PROJECT:

YOUR PROJECT NO. Langley Golf Centre
QRAMP REF NO. 6a3d76bbe291c

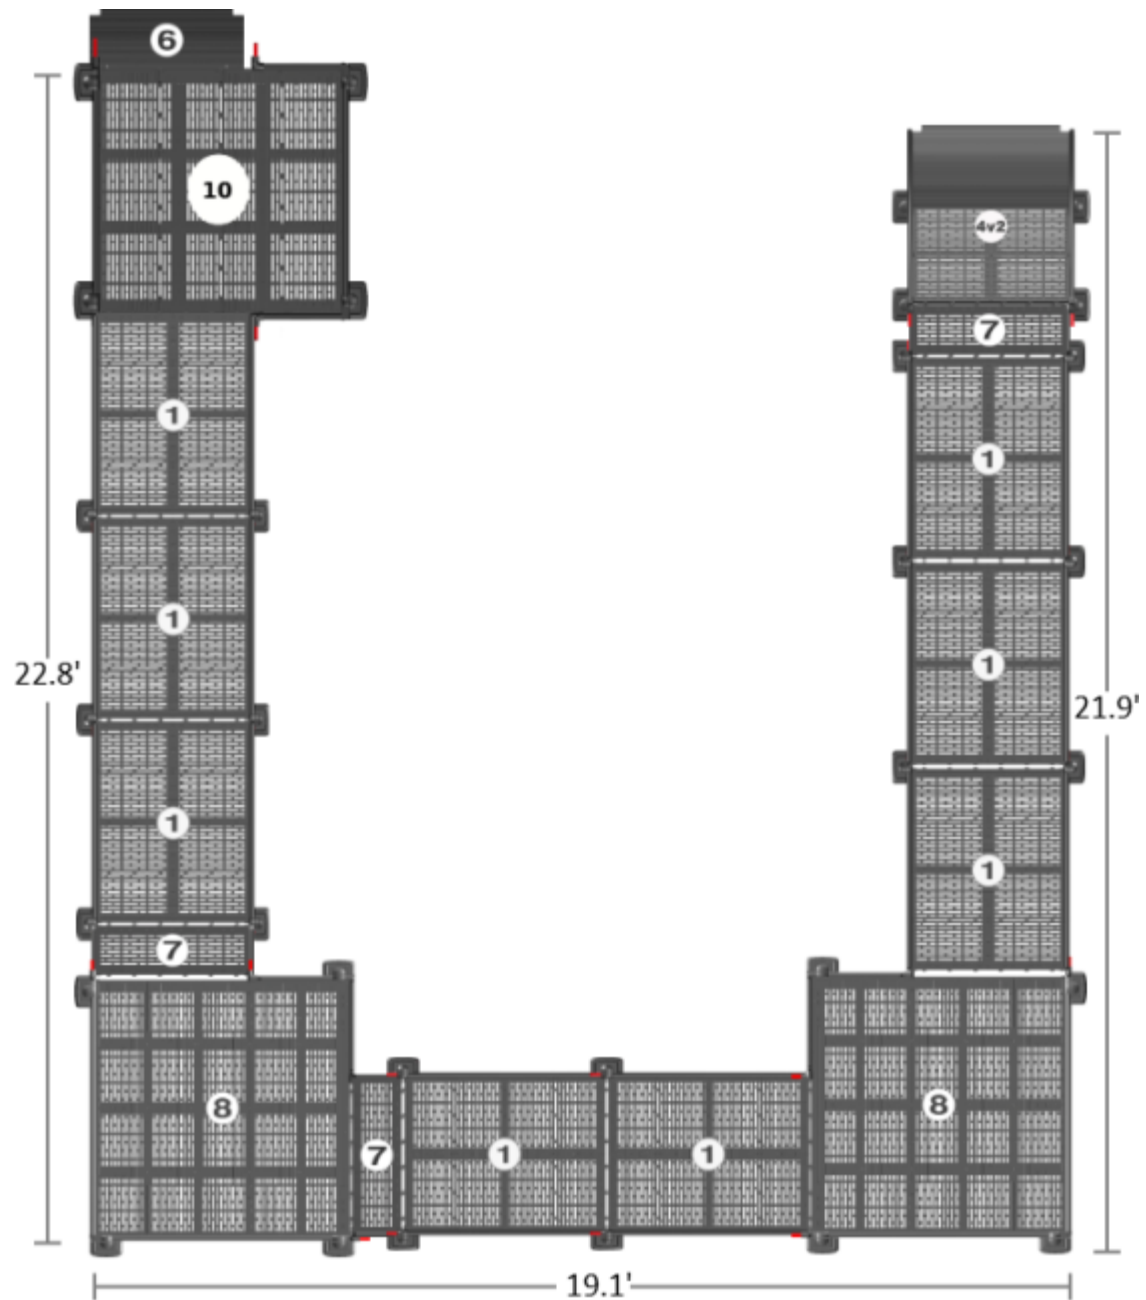
The 1st 6 needs to come off of 10 on the left side.
 10 should be 11. with stairs at the end can we
 just have a 6 come off of 7 or 1 instead of 4v2
